RE: Sidney Community Schools VARIANCE REQUEST

15. Description of Variance Request

Re: Sidney Jr - Sr High School

RE: Site Survey for Sidney Community School District Septic Tank System and Lateral Field

PLAN —————
1" = 60'-0"

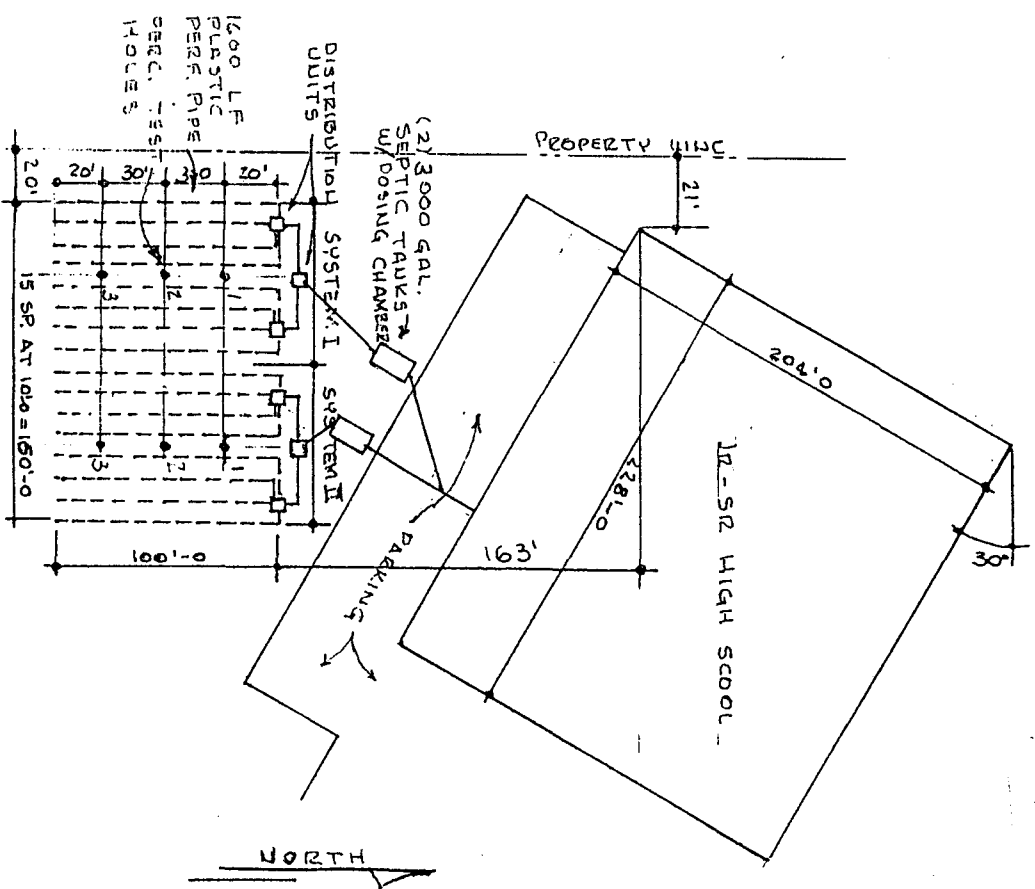
The residence is 698 feet from the NW corner of proposed disposal field. This is only a issue because the terrain of the land is significantly more important. Please refer to the attached aerial photo that shows that the contour of the land slopes away from the proposed disposal field in every direction except towards the north which is the Fremont County Fair Grounds and the Sidney Rodeo. The residence in question is at approximately the same elevation as the disposal field. Run-off, if any, would be away from the property in question. DNR representative, Fred Evans is in possession of U.S. Geological Survey maps that confirm this analysis.

The residence is 698 feet from the NW corner of proposed disposal field. This is only a issue because the terrain of the land is significantly more important. Please refer to the attached aerial photo that shows that the contour of the land slopes away from the proposed disposal field in every direction except towards the north which is the Fremont County Fair Grounds and the Sidney Rodeo. The residence in question is at approximately the same elevation as the disposal field. Run-off, if any, would be away from the property in question. DNR representative, Fred Evans is in possession of U.S. Geological Survey maps that confirm this analysis.

It is recommended that the requested variance in the separation distance be approved based upon the engineer's justification and the following additional considerations:

1. The proposed wastewater treatment facility is a buy non discharging system; therefore, any possible adverse effects on the environment, water quality or aesthetics should be minimized.
2. The proposed new school will be connected to the public water supply of the City of Sidney.
3. The separation distance of approximately 700 feet is substantially equivalent to the required distance of 1000 feet.
